T ECHNICAL INFORMATION

62995A

- Subject** ▶ Change of Switch
- For Models** ▶ 6823, 6823TP, 6824, 6824TP, 6825, 6825TP, 6826, 6827, 6951, DP3002, DP3003, DP4000, DP4001, DP4002, DP4003, JS1300
- Country** ▶ All countries
- Description** ▶ See below.

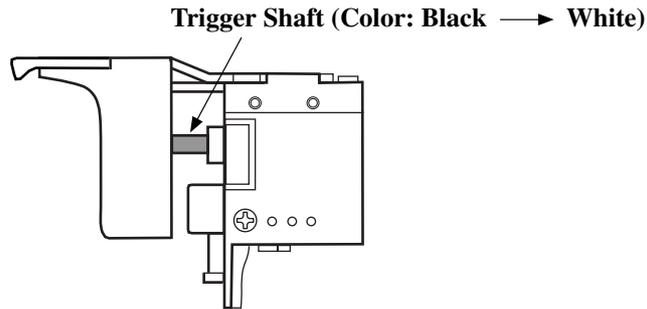
Some constituent parts of switch have been modified in order to improve the switch in durability.

The color of Trigger Shaft has been changed from black to white to distinguish the new switch from the current switch as illustrated below. However the part number and the wiring remain unchanged.
